## Responses to Referee #1 for the Manuscript ID: hess-2012-522

Title: "ASSESSING THE HYDROLOGIC RESTORATION OF AN URBANIZED AREA VIA INTEGRATED DISTRIBUTED HYDROLOGICAL MODEL" by D.H. TRINH and T.F.M. CHUI

## **Responses to Dr. Olga Barron (Referee) for the Manuscript ID: hess-2012-522**

**Fig. 1** Groundwater depth, infiltration rate and groundwater recharge across bioretention systems with different soil hydraulic conductivities. Results are from 12 hours after largest rainfall event (130mm) on 8<sup>th</sup> December 2005

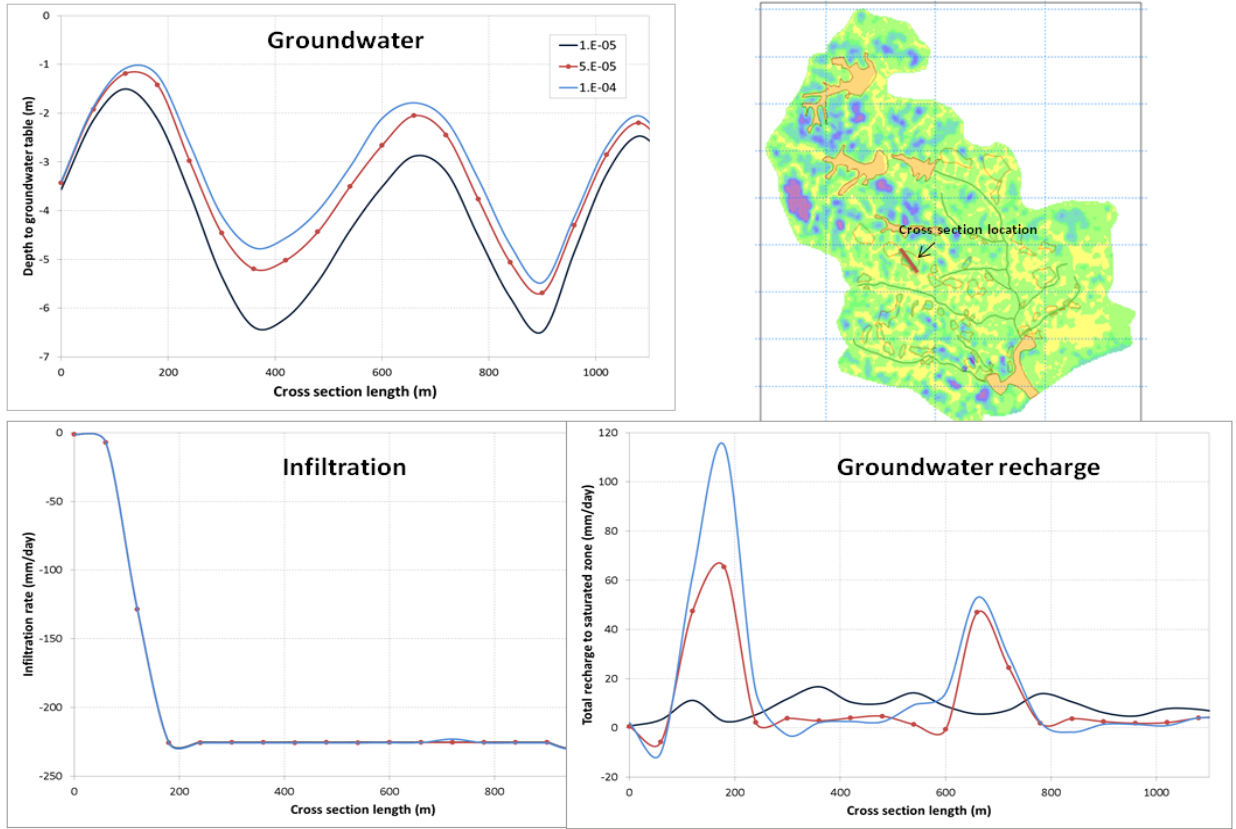
- Page 4108, line 23: the hydraulic conductivity of the soil is very similar to that of soil in bio-retention systems; I would have expected bio-retention systems to have larger hydraulic conductivities, of the order of 150-200 mm per hour (instead of about 40 mm per hour as used by the Authors).

- Page 4115, lines 9-14: according to the chosen parameters, the hydraulic conductivity of bio-retention systems is similar to that of the surrounding soil. This allows water to percolate into the surrounding soil, without accumulating in the systems. I would consider to increase the soil hydraulic conductivity of bio-retention systems to see the effect of recharge.

- Secondly, in response to the referee's comment, we have also carried out two more simulations using bio-retention systems with soil hydraulic conductivity of  $5 \times 10^{-5}$  m/s (180 mm/hr) and  $10^{-4}$  m/s (360 mm/hr) which are higher than the original value of  $10^{-5}$  m/s (36 mm/hr). The results show that the difference in outlet discharge among the scenarios is insignificant. Taking a bio-retention system at the centre of the catchment as an example, Fig. 1 presents the groundwater table, infiltration rate and groundwater recharge across the system 12 hours after the largest rainfall event in the simulated year. This event has a rainfall depth of 130 mm and an intensity of 26 mm/hr. The infiltration rates of the different scenarios are the same, as the rainfall intensity is lower than all the soil hydraulic conductivity values. There is more recharge to the saturated zone at that particular moment leading to a higher groundwater table in the scenario with higher soil hydraulic conductivity. However, the total recharges of all scenarios reach the same values eventually. The temporal difference in groundwater recharge is because rain water requires different duration to travel through the unsaturated zone to reach the saturated zone depending on the soil hydraulic conductivity. Therefore, we believe the original soil hydraulic conductivity of bio-retention system is reasonable as increasing soil hydraulic conductivity does not affect the overall recharge amount.

Fig 2. Groundwater (GW) table depth and vegetation distribution Marina-like catchment

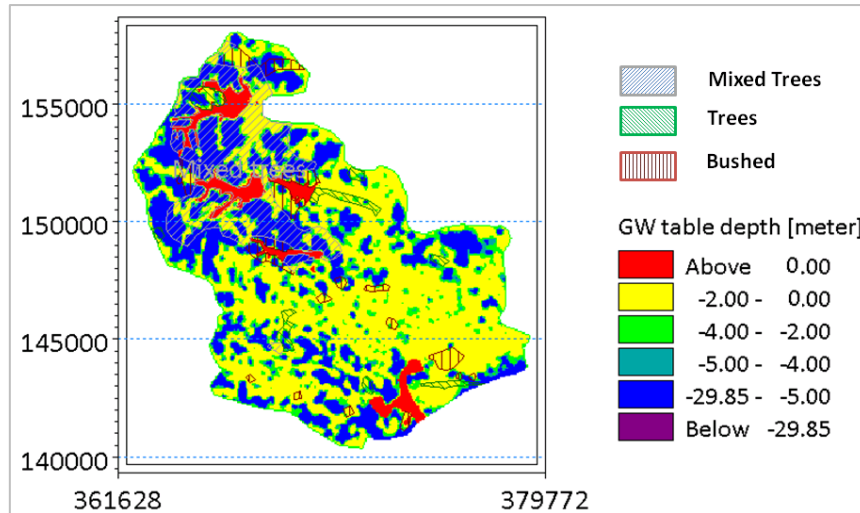
Table 1: the root depths are well below the water table; this is unlikely, since many species would suffer under such conditions. The Authors should provide a reference to justify this choice.

**[Response]** According to Singapore National Parks Board (Npark), tree height in Singapore varies in the range from 4 meters to more than 20 meters (NPark, 2011). Based on the relationship between tree height and root depth from Štofko (2010), the root depth is approximately 3.5 meters for a 4.0 meter tree. In addition, a recent survey in Singapore shows that the root of vegetation can be more than 3 meters (Ngo et al., 2013). Thus, we believe that our assumption on root depth is reasonable. Furthermore, most of the vegetation with deep roots locates in the upstream of the catchment where the groundwater table is mostly below 5 meters (Fig 2). The rest, locating in the downstream area, either has shallower root or is wetland vegetation that is more resistant to flooding conditions.

**Fig 1. Water balance aggregated over one year for different scenarios with a lower soil hydraulic conductivity**

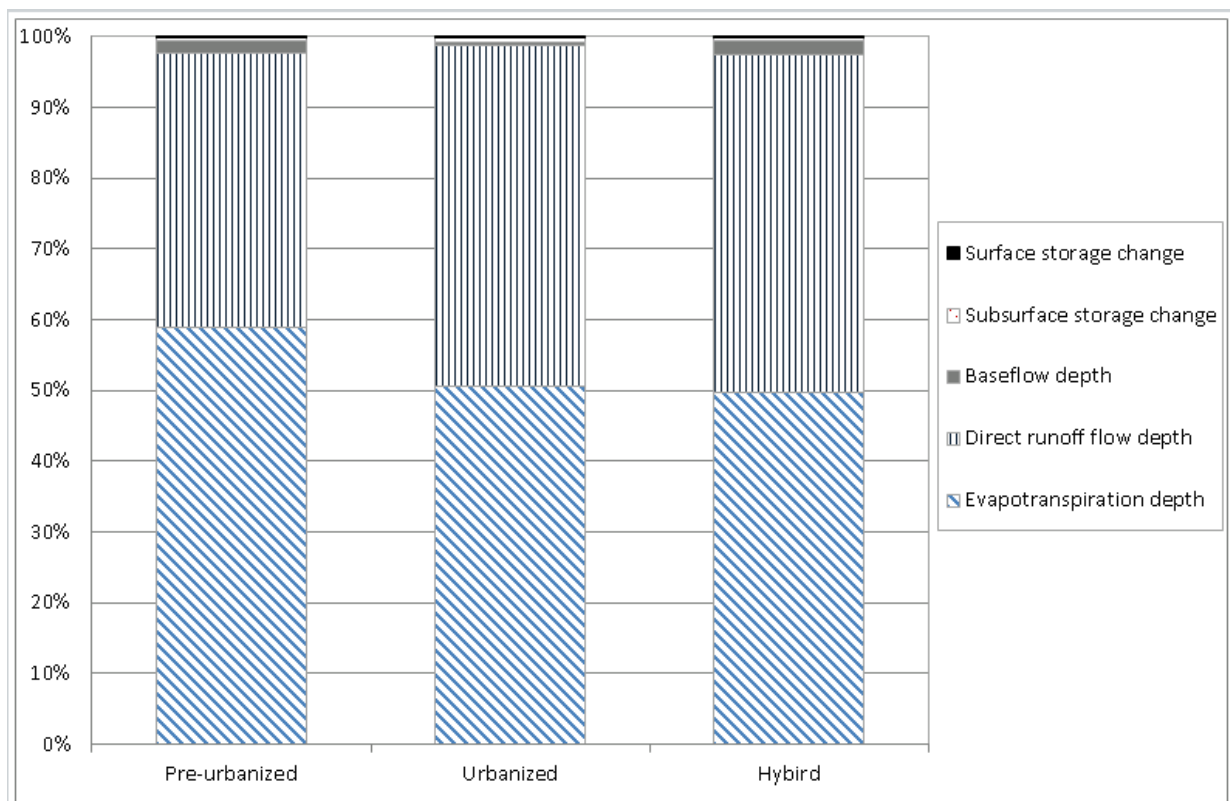
2. The main concern about the reviewed paper is related to an absolute lack of any observation data (apart from meteorological data), and all presented results and discussion are solely based on the model outcome. This is the main limitation of the suggested results: the model doesn't seem to be validated at all. In couple models, rainfall partitioning to recharge and runoff is depended on the soil properties, and it is very sensitive to unsaturated zone parameters. Incorrect partitioning, resulting from inadequate parameters selection propagates the error to simulated river flow. How much trust one can put in the model outcomes, when no evidences were offered on whether the model treats the rainfall

partitioning correctly? Even in relative terms, the analysis of difference between selected scenarios on baseflow or peak flow could be wrong.

We also agree with Dr. Barron that rainfall partitioning to recharge and runoff is sensitive to soil properties. We therefore simulate the different scenarios with a soil hydraulic conductivity that is one order of magnitude lower. For the aggregated water balance over one year (Fig.1), the rainfall partitioning still follows the same patterns as the original simulation. For example, when compared with the pre-urbanized scenario, there is still close to a 10% increase of direct runoff and 10% decrease in evapotranspiration in the urbanized and hybrid scenarios. There is also more baseflow in the hybrid scenario when compared to the urbanized one due to the green structures.

**Fig 3. The influences of time step and rainfall data resolution on peak outlet discharges in Bio-retention scenario**

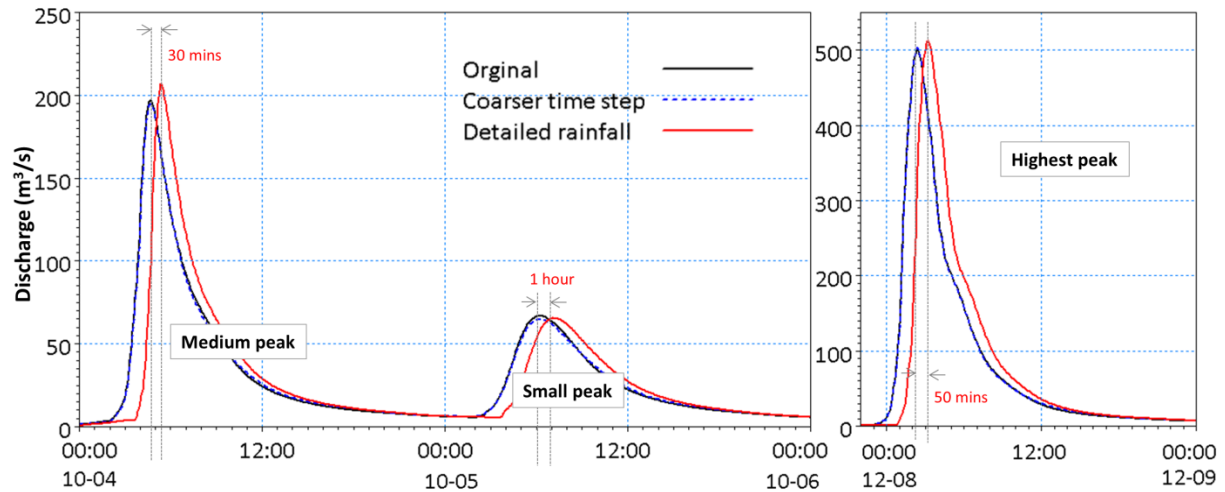
Was any sensitivity analysis applied to assess 1 hourly rainfall data distribution with that hour on the simulated river flow and particularly the peak flow analysis?

The peak outlet discharges (i.e., highest peak, medium peak and small peak) of the above two simulations are presented in Fig. 3 together with those from the original simulation. The increase in simulation step sizes does not affect the time and the magnitude of the peak discharges. The more detailed rainfall input increases the peak discharges at most  $20 \text{ m}^3/\text{s}$ , and changes the time of occurrence by at most 1 hour. However, the changes are not significant enough to affect the main conclusions of this study. Thus, we think the original rainfall data interval and the simulation step sizes are reasonable for this study.
